Environmental Review Team Report

Czaczkes Property

Sprague, Connecticut

ENVIRONMENTAL REVIEW TEAM REPORT
ON
CZACZKES ZONE CHANGE
SPRAGUE, CONNECTICUT

Drainage Areas

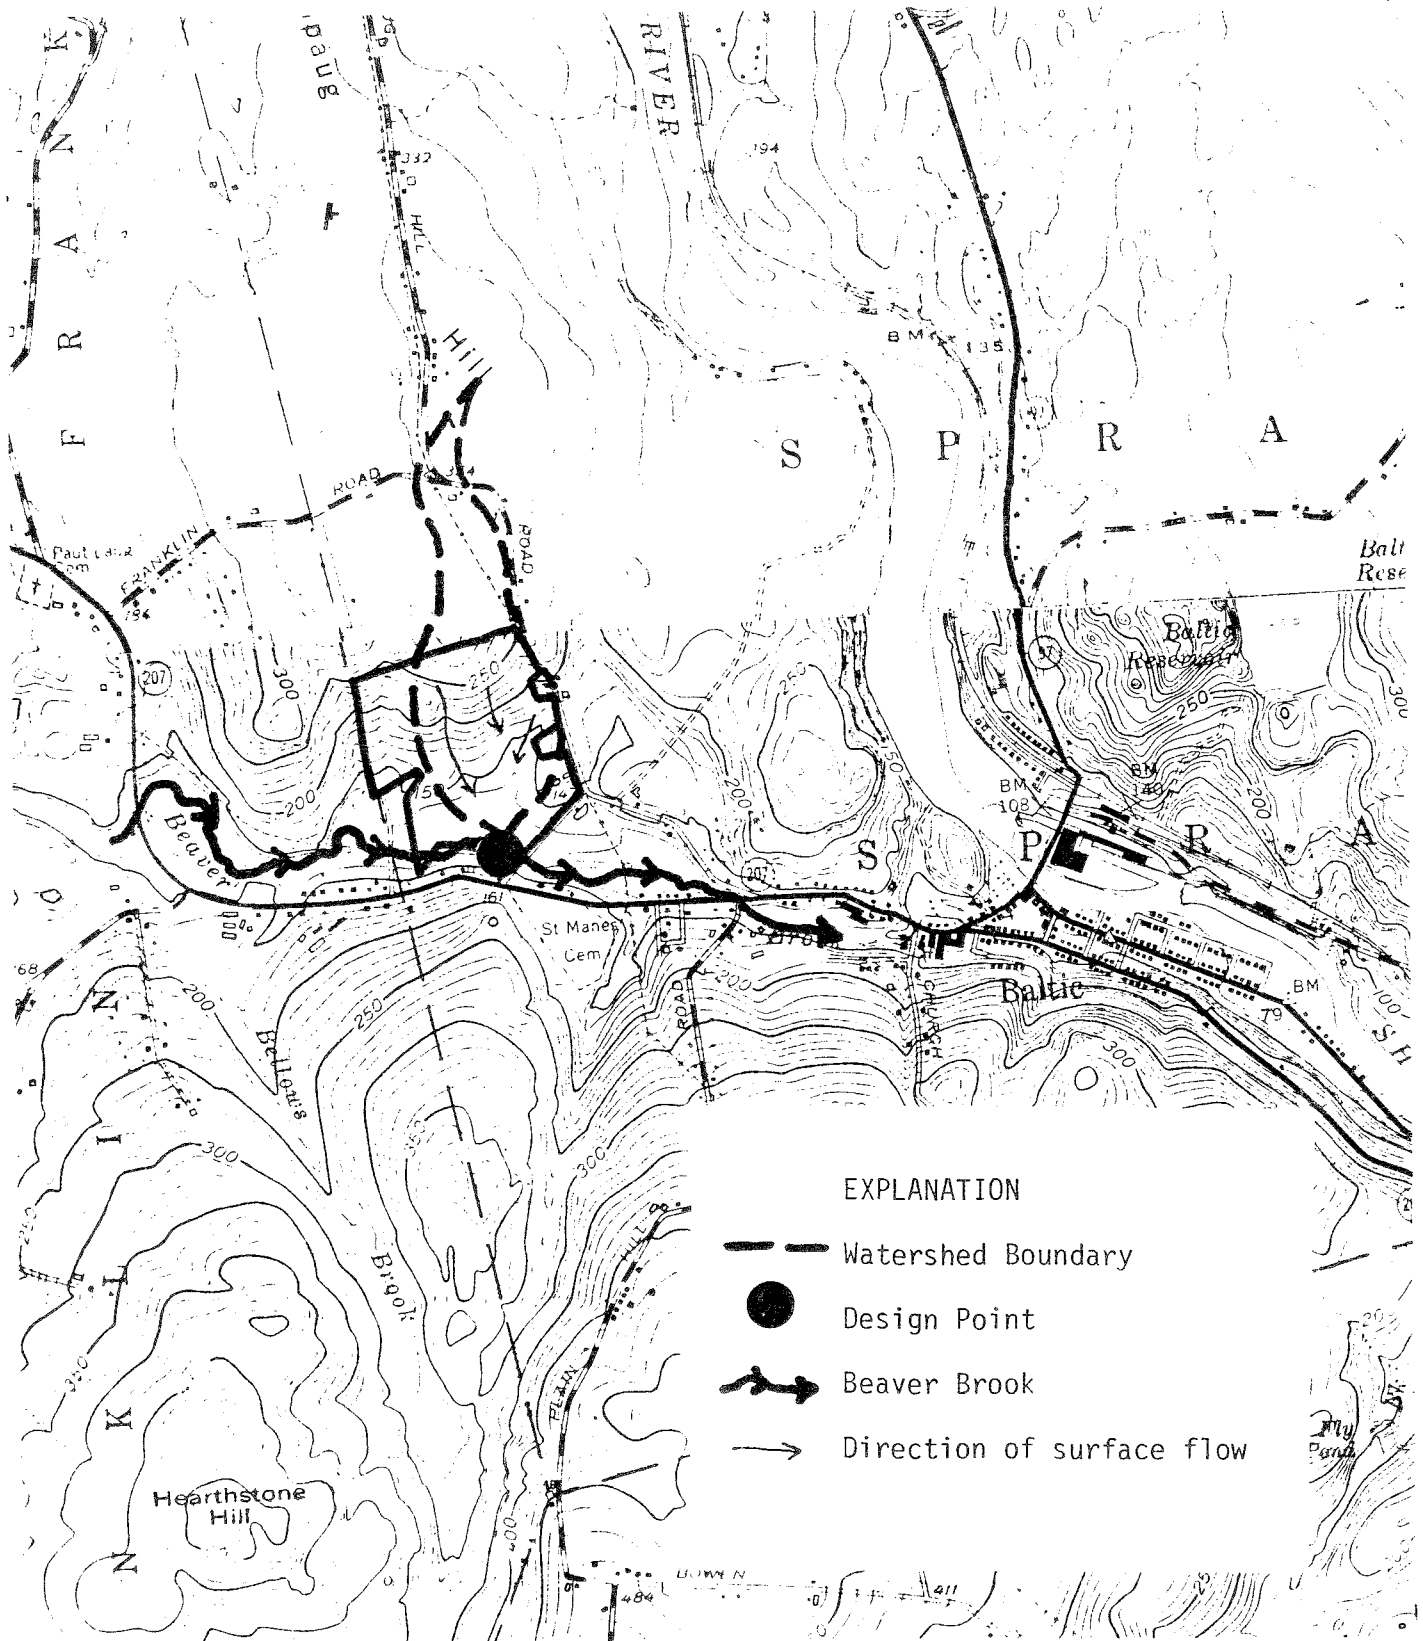
The site lies within the watershed of Beaver Brook. The surface and ground-water on the parcel flow generally downslope toward local discharge areas. The local discharge areas on the site include intermittent as well as permanent drainage channels. Water is routed through these channels toward Beaver Brook. Based on soil mapping information, wetland soils tend to parallel the intermittent as well as perennial watercourses on the site. Development and/or disturbance of these areas should be avoided.

Development of the site as discussed will lead to increase in the amount of surface runoff produced during periods of precipitation. The increases will arise from the conversion of permeable soils to impermeable surfaces (roof tops, paved roads and parking areas, etc.), and from the removal of vegetation. The added runoff could cause increased overland and stream-channel erosion, and it could increase the peak flows of the streams on the site. These issues should be addressed by an erosion-and-sediment control plan. This plan should be followed during the construction phase, and by establishing some type of run-off control device, such as a detention basin. The applicant's engineer stated on the day of the field review that the farm pond in the eastern section of the site may be potential detention basin for the site and depending on final plans, possibly another detention basin would have to be constructed on the parcel.

It is possible to estimate the magnitude of the runoff increases that would occur under the existing R-1 zone (40,000 square feet) and under the desired R-2 zone (20,000 square feet). The estimates below are based on the runoff curve number method, as outlined in SCS Technical Release No. 55. For the purpose of analyzing the increase in storm water runoff from the property, it was assumed approximately 40 acres of the total 67 acres would be developed. Also, a design point or point of outflow on Beaver Brook and its respective drainage areas was chosen by the Team's hydrologist. Since there was no finalized plan and/or site plan to determine the amount of impervious surfaces created by paved roads and parking areas, these computations, therefore, do not account for potential access roads and/or parking areas. Depending upon the amount of paved road or parking areas created, the curve number and ultimately, the runoff depths for each or the rainfall amounts would be expected to increase. Estimates are provided for 24-hour rainfall amounts that would be expected to occur in any given year. These rainfall events are the 10, 20, 50, and 100 year storms having, respectively,

The increases shown in the table above are significant enough under the R-1 or R-2 zone, to merit the careful consideration of stormwater management on the site. It is suggested that the applicant be required to submit detailed hydrological information once development plans are finalized. This information should include pre- and post-development runoff estimates from the site for the 10, 25, 50, 100 year storm events. Detailed design specifications for all stormwater detention basins should be submitted and reviewed by all appropriate town officials. In addition, it is further suggested the project engineer take a close look at downstream culverts on Beaver Brook to determine if they can handle post development flows from the site.

Vegetation

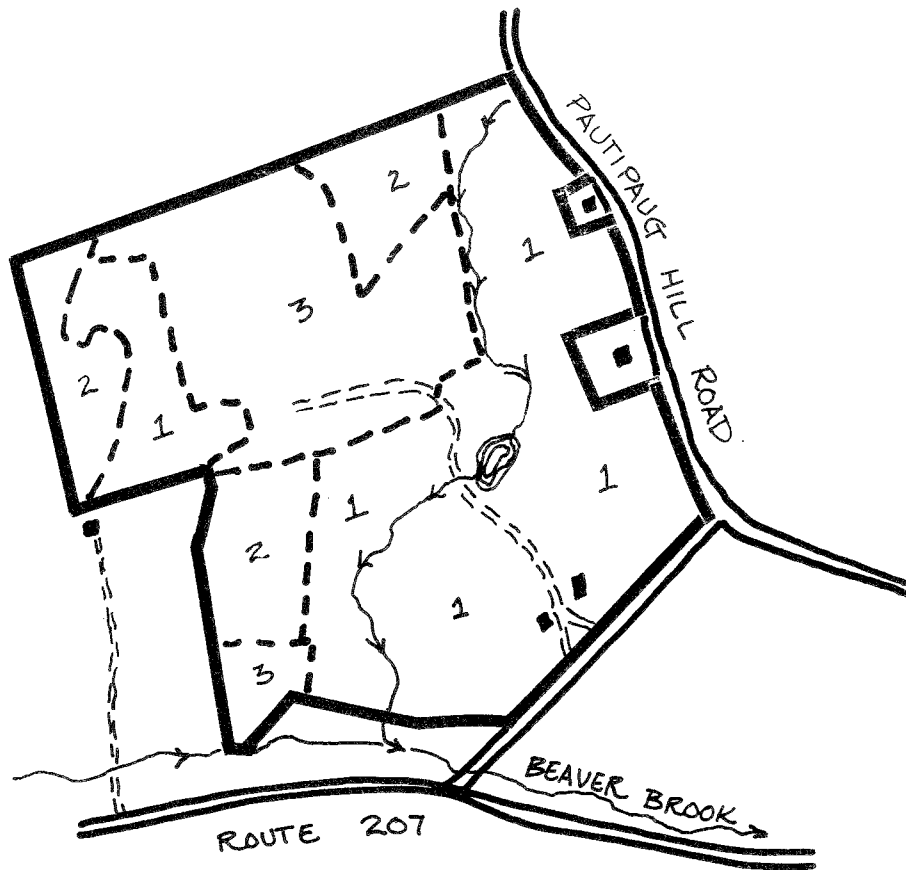
There are only three major vegetation types involved in this property. The areas labeled #1 on the accompanying vegetation map, are presently hay fields. They have been actively managed for hay production. The change in housing density would only make the grass areas smaller. Without the proper planning, the only real problem would be an increase in storm water runoff.

Areas shown as #2 are abandoned pastures and fields that contain some grass areas, but the area is filling in with red cedar, hickories, black birch and red maple. High density housing would remove most of the tree cover, which would not be a high economic loss, but it would change the appearance of the site and would be detrimental to the wildlife that now inhabits the area.

Area #3 is the most heavily wooded portion of the site. The present forest cover consists of black oak, white oak, scarlet oak, pignut hickory, shagbark hickory, black birch, and red maple. Not only would high density housing remove most of the tree cover, but due to the numerous outcroppings of bedrock, the residual trees that might be left would be highly subject to blowdown because of the very shallow soils. High density housing in this area would create real problem with the present tree stand; the only safe trees to leave would be those that were in the deeper soils between the bedrock outcrops. Even low density housing (1 acre lots) should be planned very carefully on these steep shallow soils. The area seems more suitable to even larger lots (two or more acres in size). These would allow more choice in the actual house location and would be less disruptive to the forest stand.
